# Seaside Greenway South Assessment Ride 1

HUB Vancouver UBC Local Committee - *Seaside South Working Group*  
24 June 2015

Figure 1

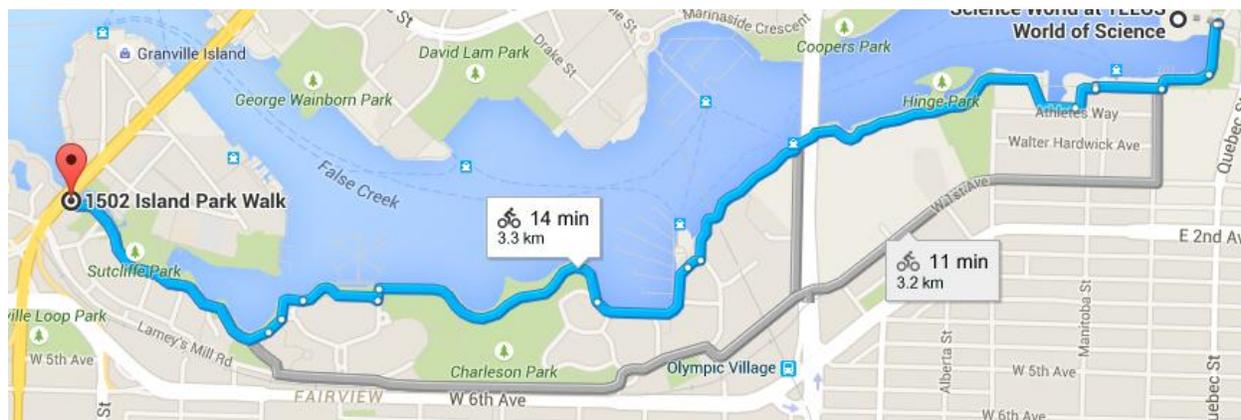
The complete Seaside Greenway is almost 30 km from end-to-end. The older, less well designed section from Science World along the south bank of False Creek out to Pacific Spirit Park is almost 12 km long. In order to manage the effort involved with assessing this section, it will be assessed in smaller segments. The first assessment considers only the section from Science World west to Granville Island, approximately 3 km. This is shown in Figure 1.

Figure 15

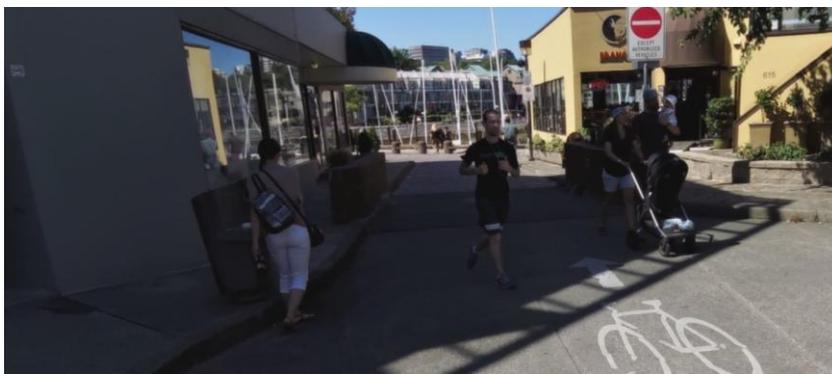
Figure 15 illustrates the chaos at the western side of Stamp's Landing. The No Entry sign does not mention bicycles.
